VA Hot Springs DOM Renovation Building 8  
Hot Springs, South Dakota

**ADDENDUM NO.:** 01**DATE ISSUED:** 08-22-2025**BIDS DUE:** 09-03-2025**ARCHITECT'S PROJECT NO:** 211921

**Date:** 8/22/2025**Project:** Dom Renovation for Semiprivate Rooms**To:** All Plan Holders**Project #:** VA# 568-20-208, WPE# BR21039**From:** David Dowling/Michael Heinrich, Mike Sigman**Project Location:** Hot Springs, South Dakota**Addendum Number:** #001

1 ENLARGED BASEMENT PIPING PLAN - HEATING WATER  
1/4" = 1'-0"

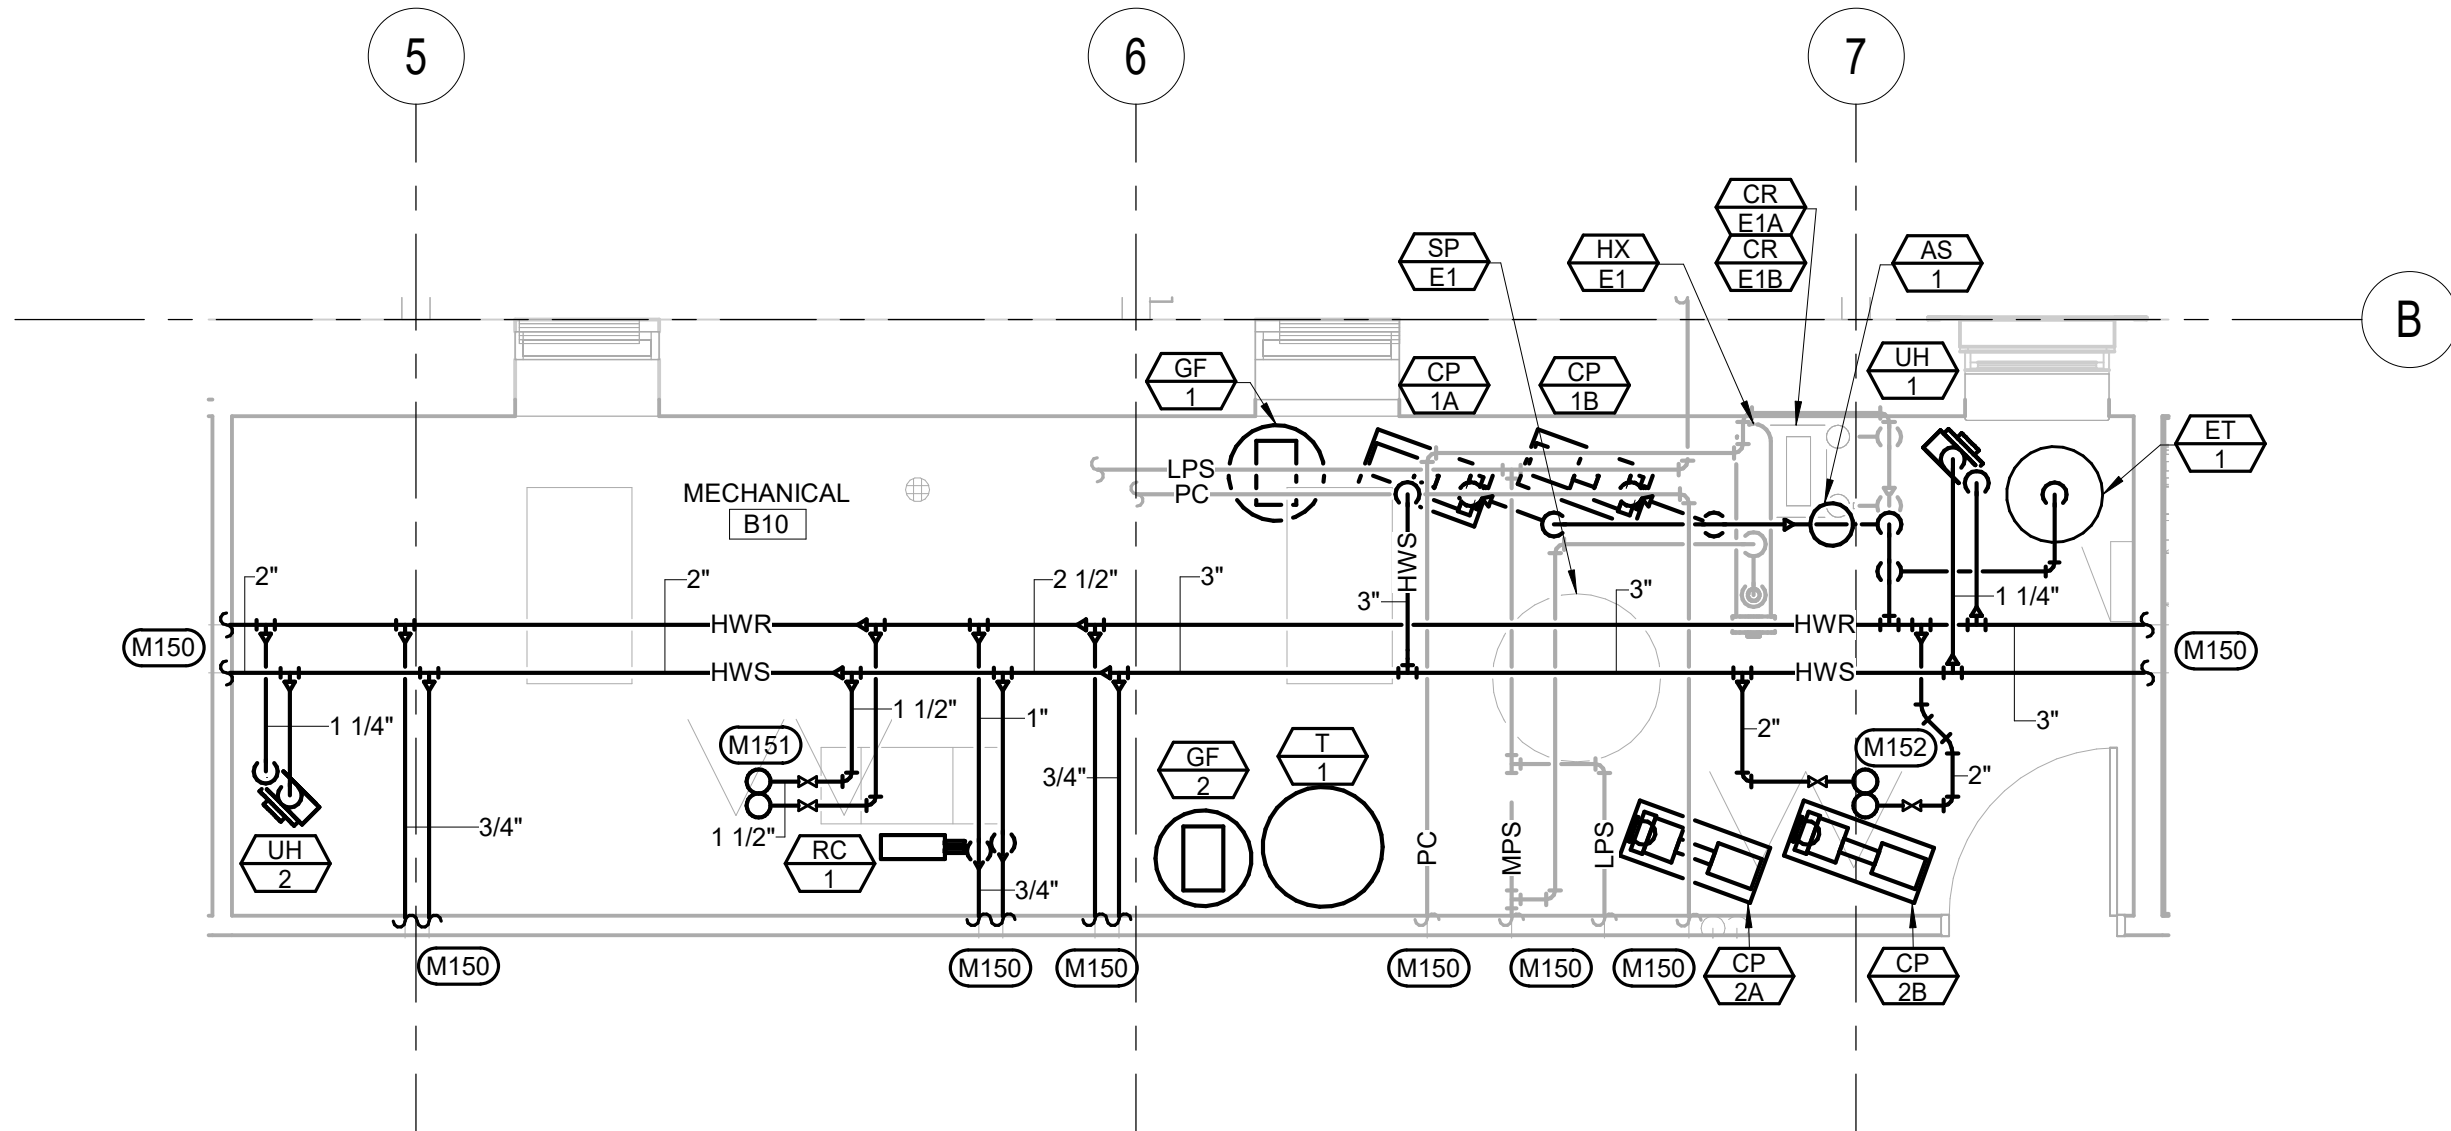
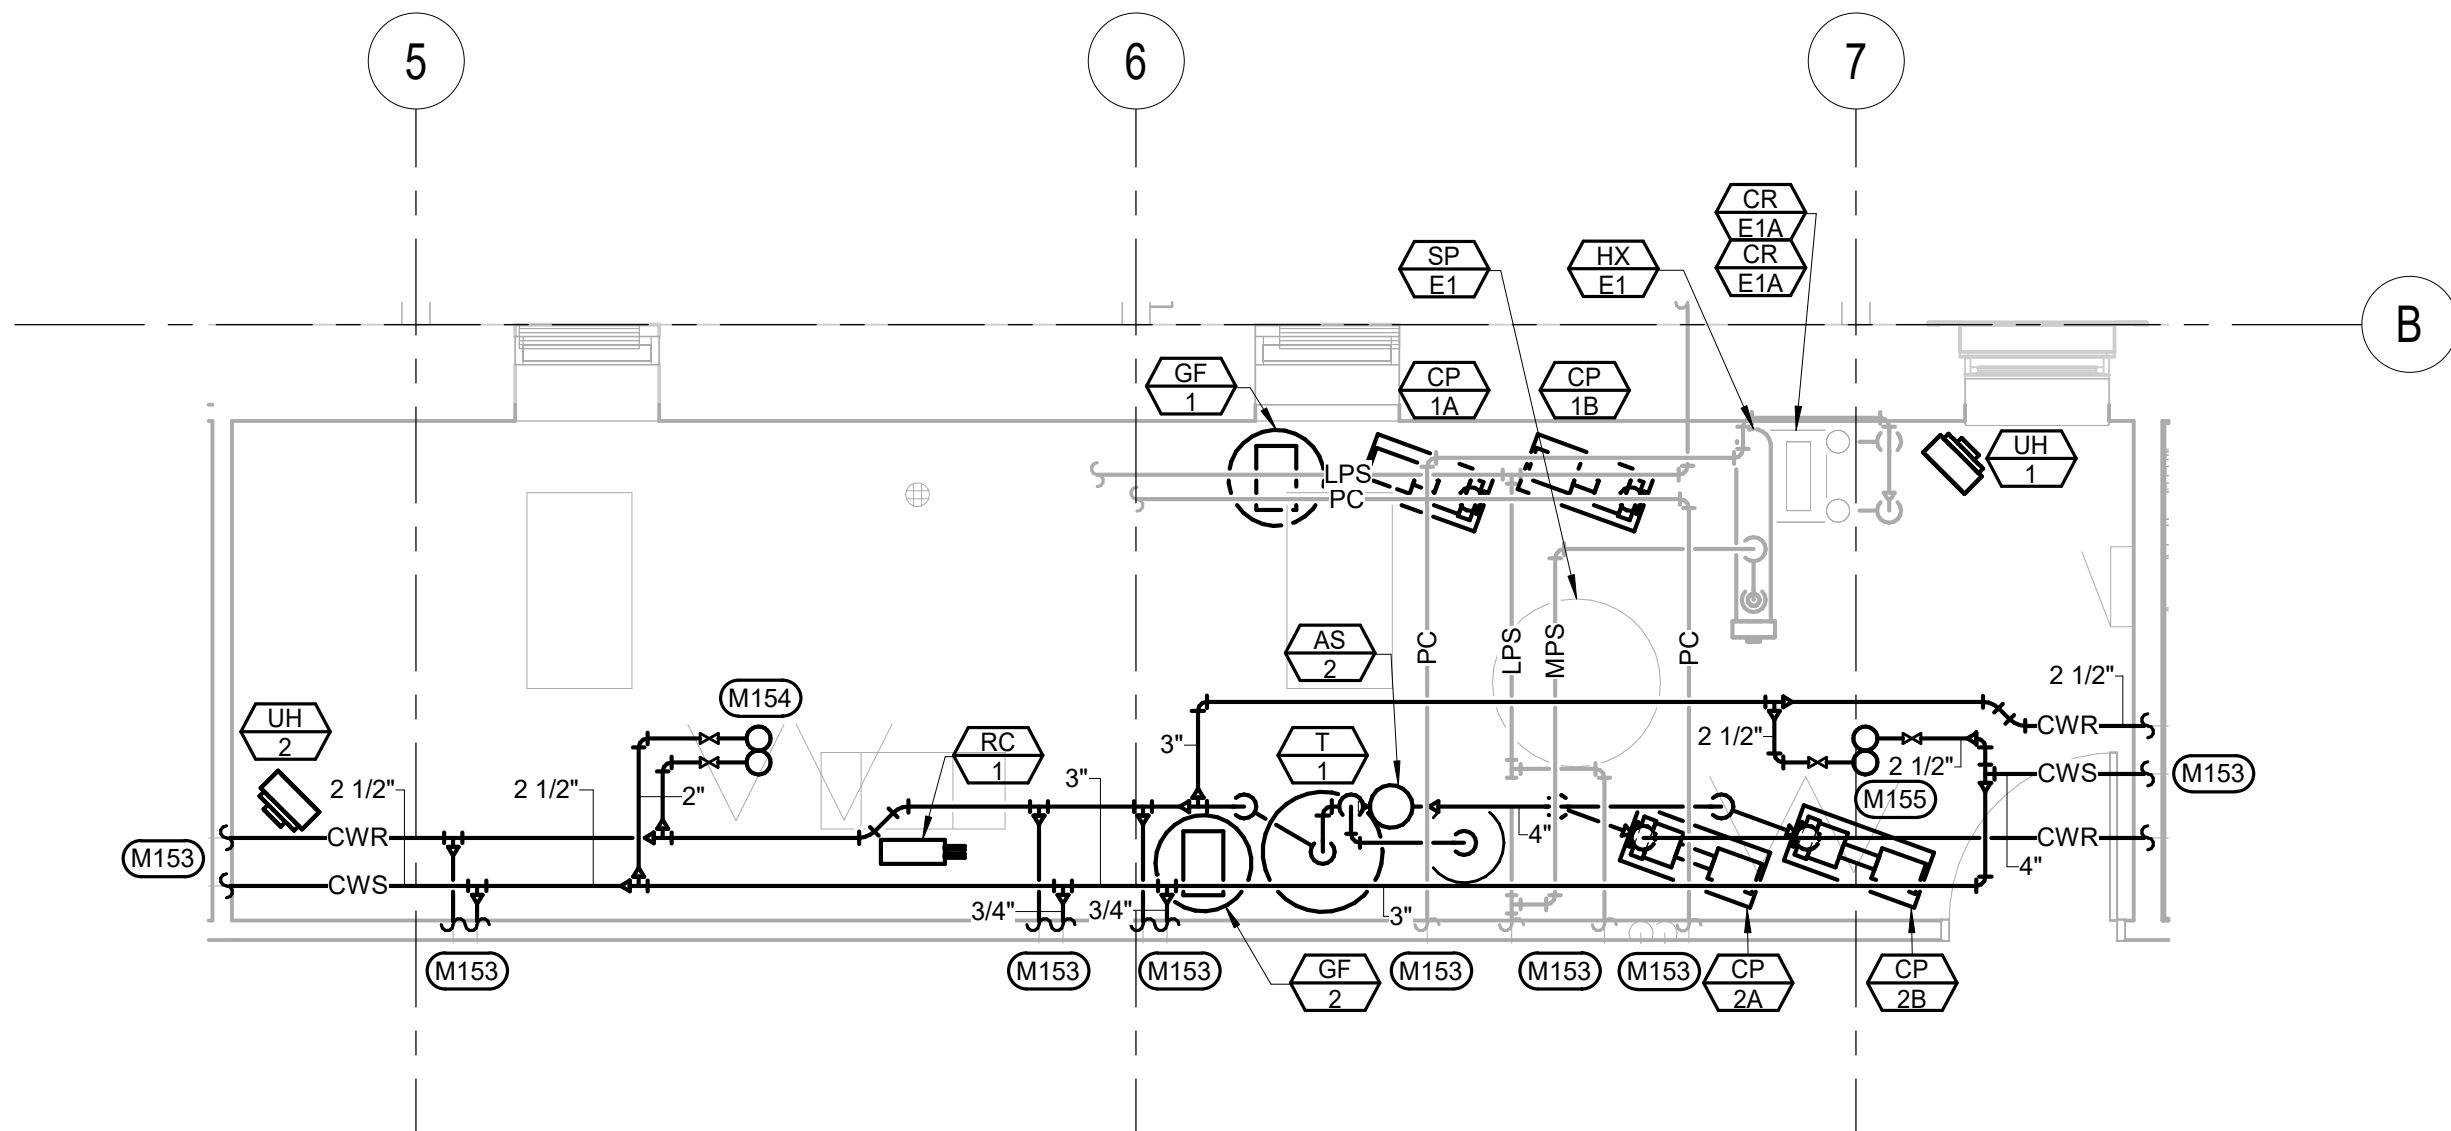
## Sheet MP-103

1. Add the attached sheet MP-103.

7 TYPICAL PAD MOUNT MECHANICAL EQUIPMENT DETAIL  
NO SCALE

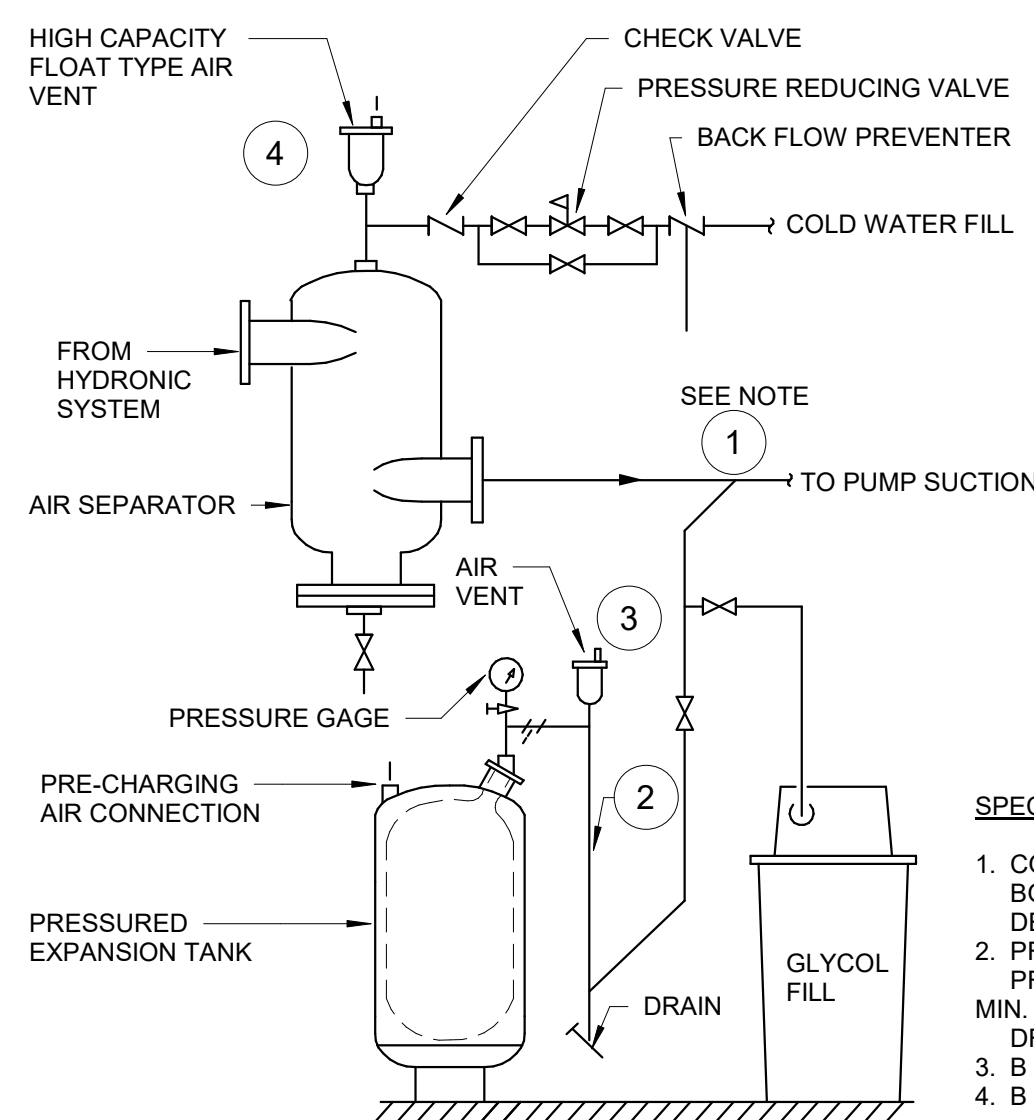
1. Revise the Sequence of Operation to indicate that FC 2-07 and FC 2-08 shall have 3-way control valves for the heating water coils.
2. Remove the control schematics from Sheet MJ-101. Add typical pad mount mechanical equipment detail, as shown on the attached sheet MJ-101.

1 FIRST FLOOR POWER PLAN  
1/8" = 1'-0"

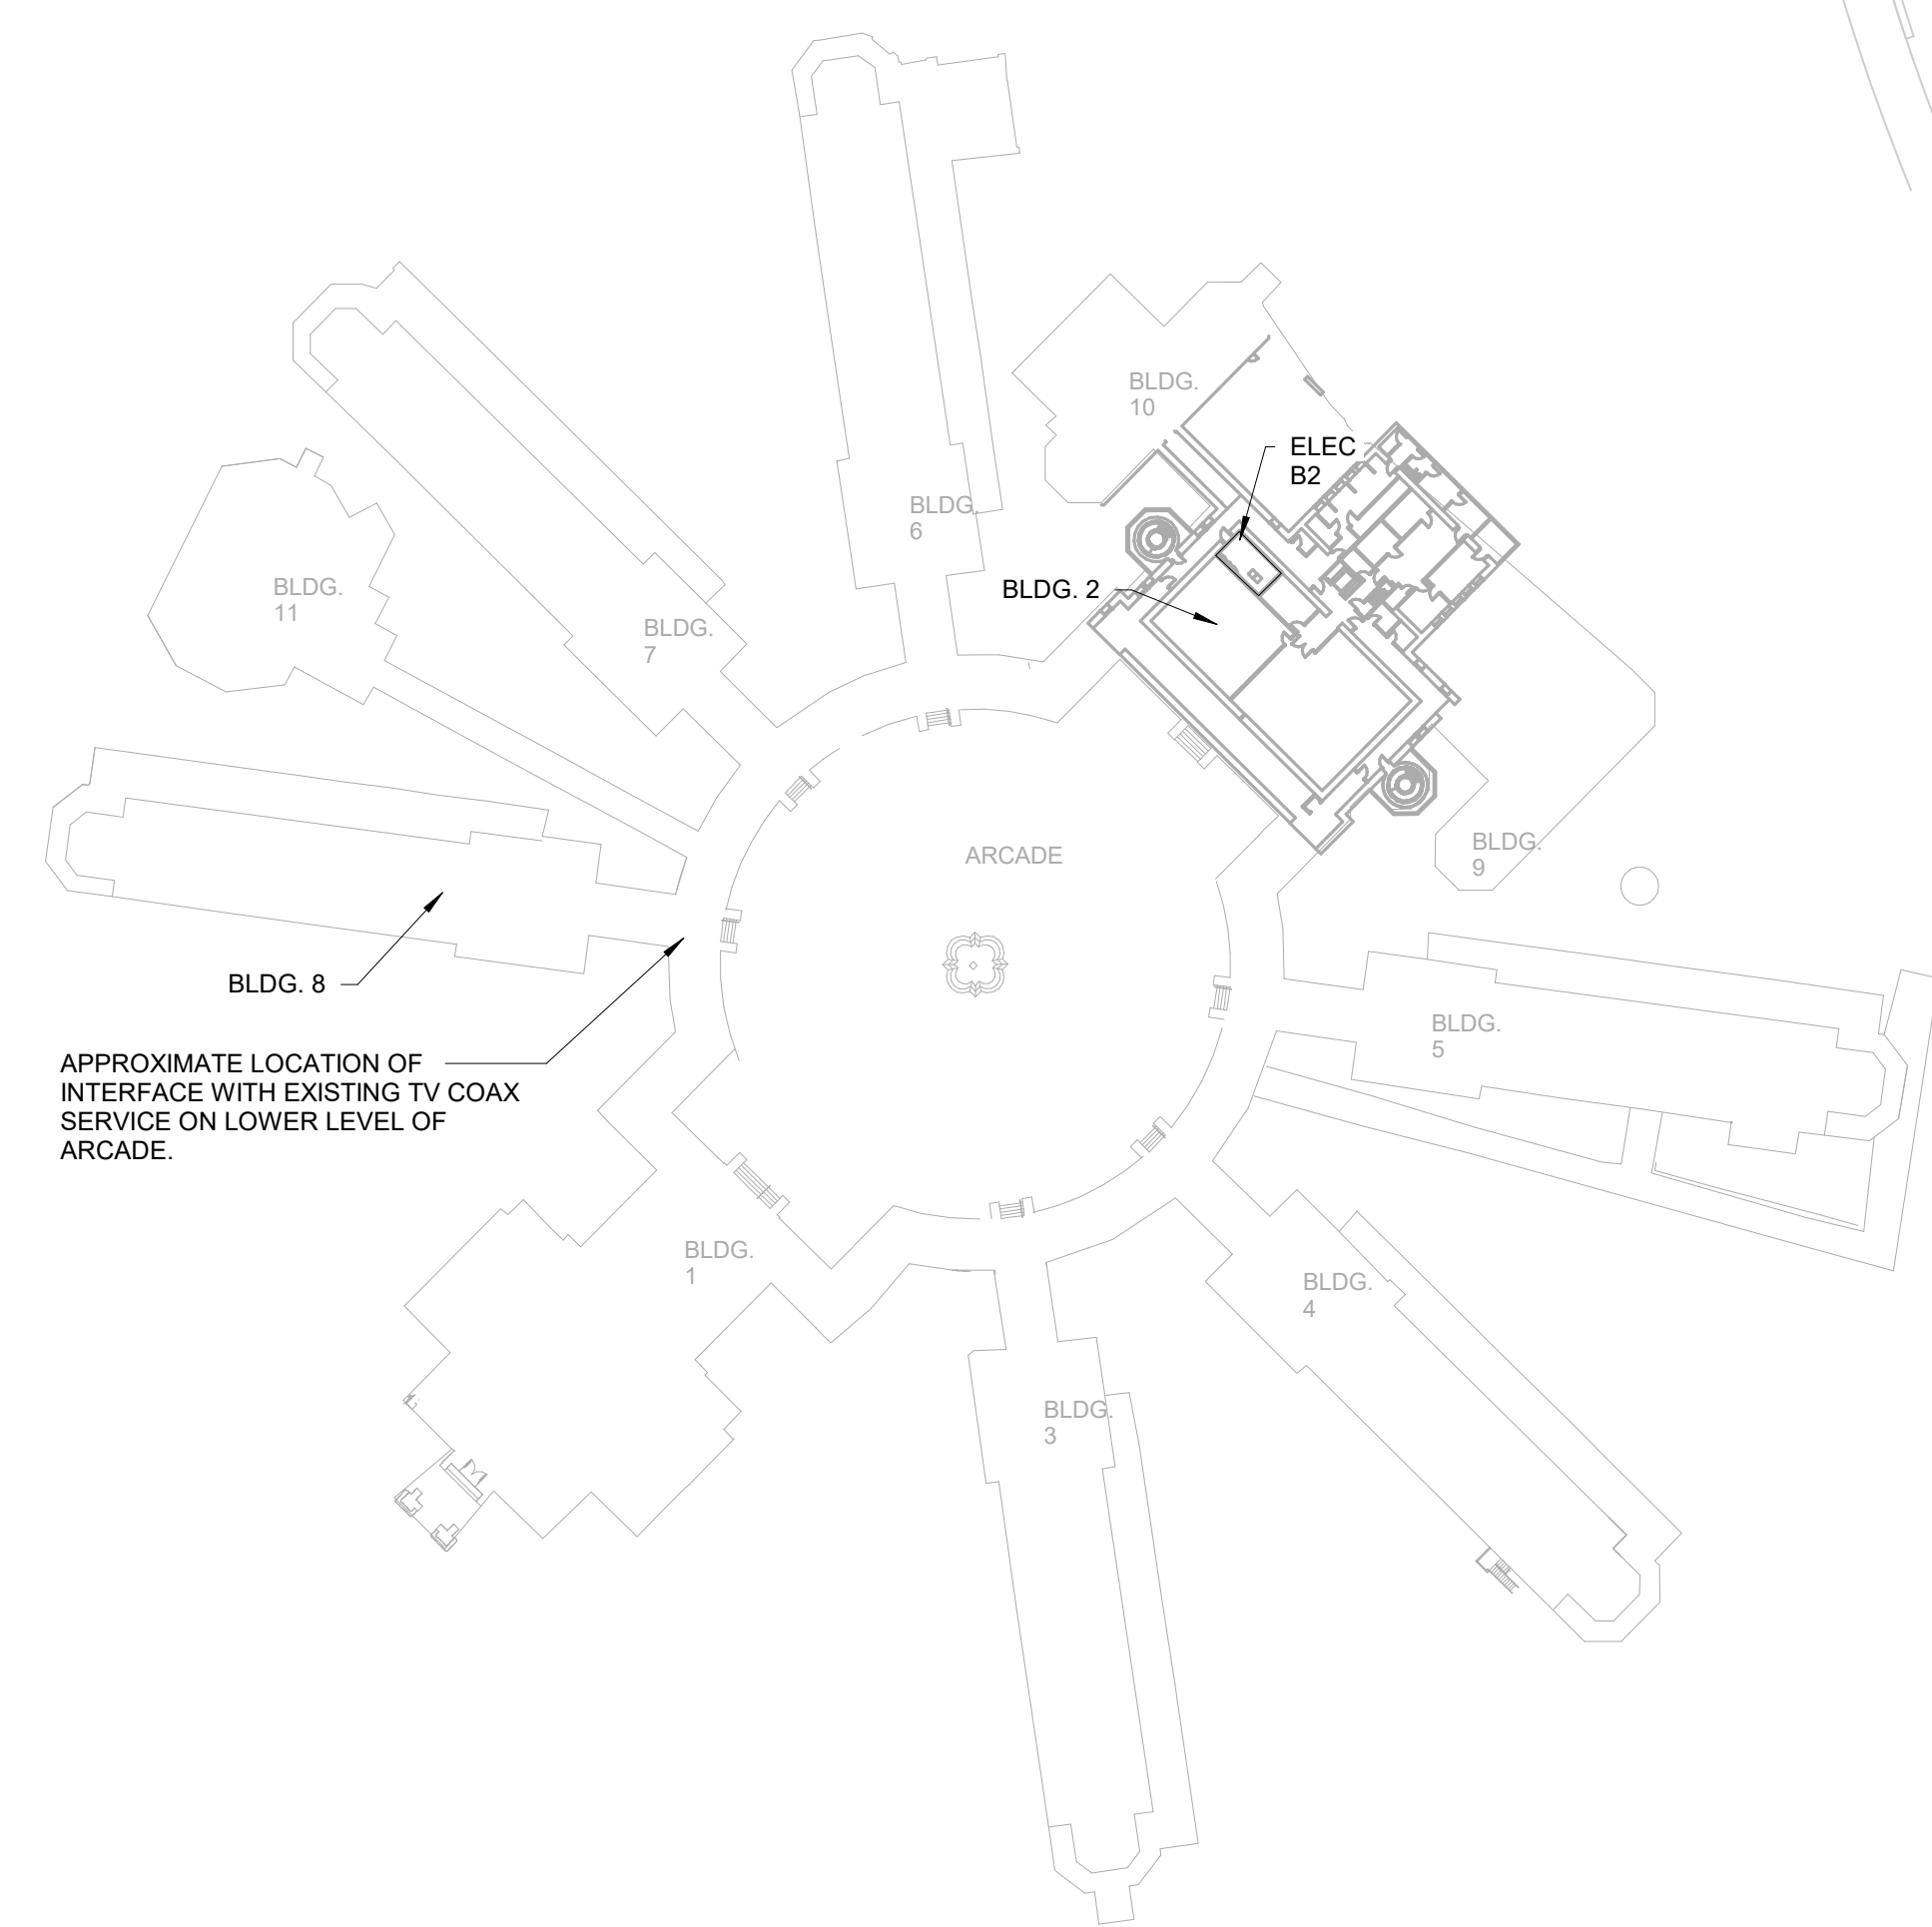
1. Modified specific note E213 as shown on the attached revised sheet EP-202-R1.
2. Added specific note E216 at door X1B as shown on the attached revised sheet EP-202-R1.
3. Removed ADA Operator from door X1B as shown on the attached revised sheet EP-202-R1.
